COMMENT #102

Cable Assembly

Common Mode to Common Mode Return Loss Limit

Bruce Champion, TE

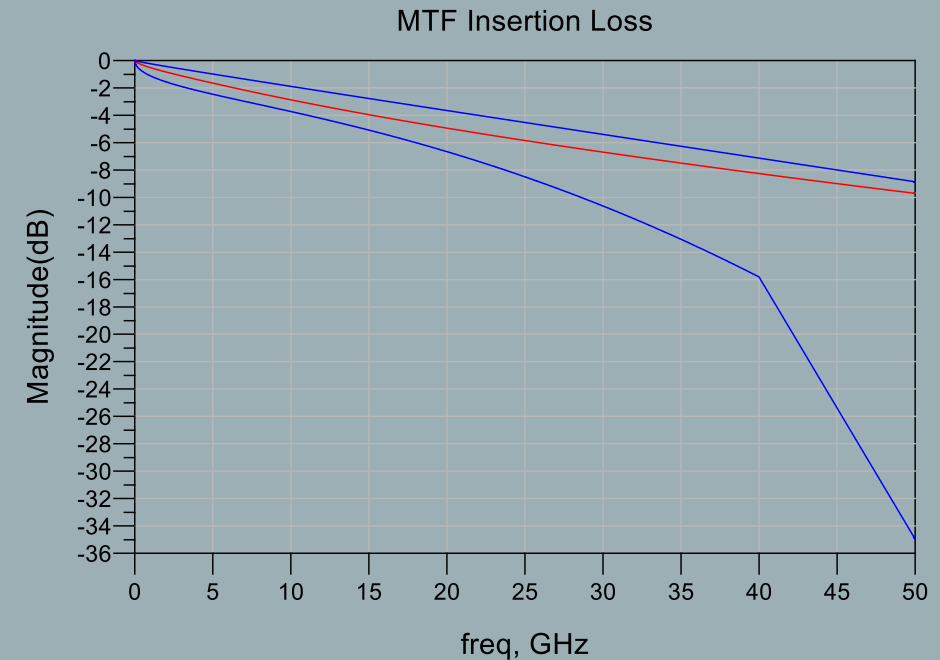
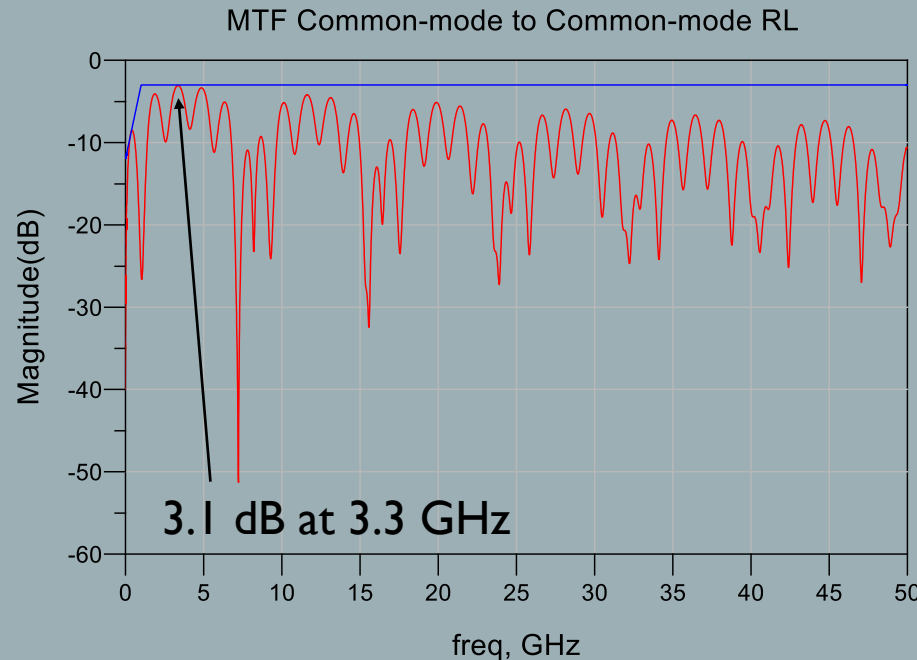
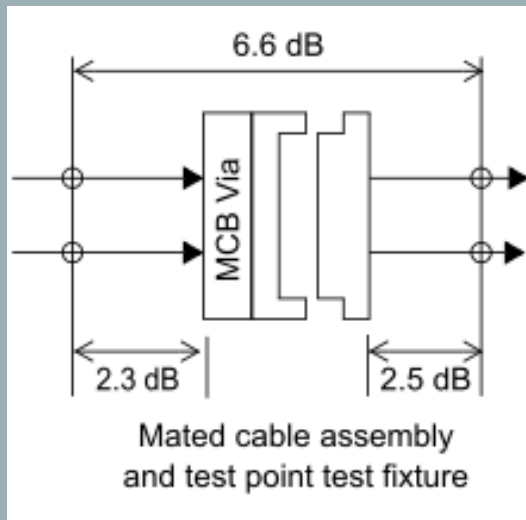
Issues with Existing Limit

- Existing cable assembly limit needs slight modification to correlate with existing MTF limit
- To demonstrate this, a MTF set-up was replicated using stripline trace such that the MTF is close to the 3dB limit for common-mode to common-mode RL
- MTF insertion loss shown on bottom right for reference

Cable Assembly Common-mode to Common-mode RL

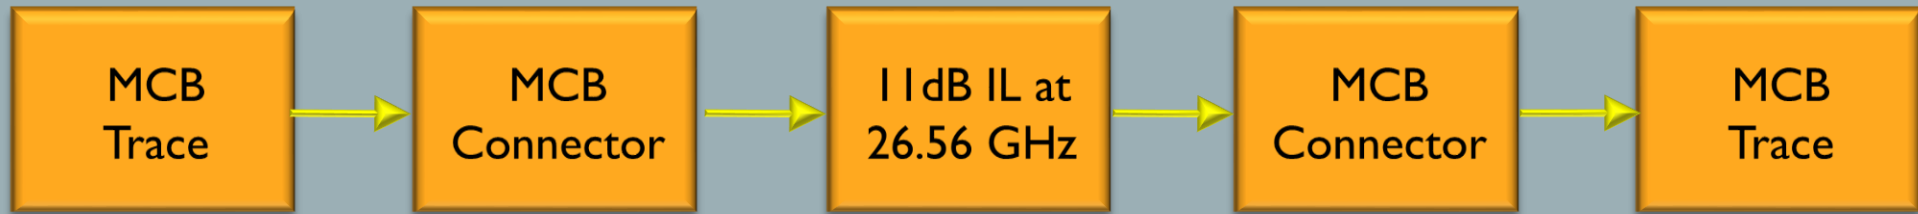
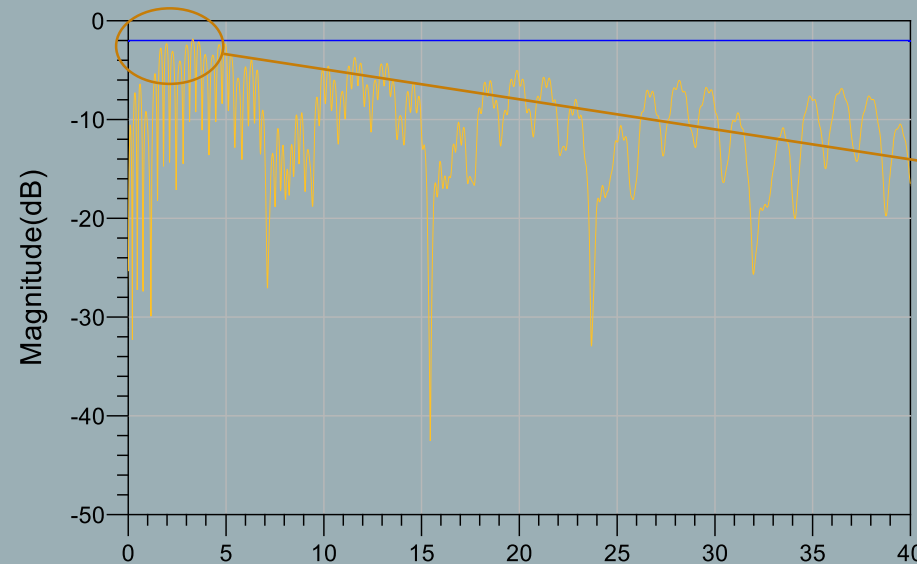
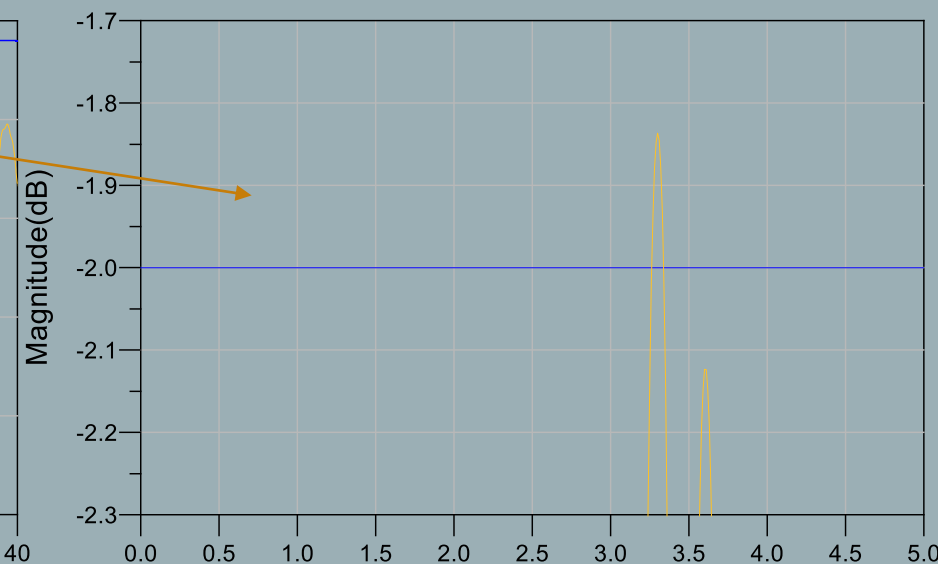
- MTF set-up from previous slide now used in cable assembly channel
- Cable assembly measurements using MTFs close to the CM-to-CM RL limit cause marginal failures
- As a result, a limit of 1.8 dB is proposed for CM-to-CM RL

Proposed Limit

$$\text{Return Loss}(f) \geq 1.8 \text{ for } 0.05 \leq f \leq 40$$
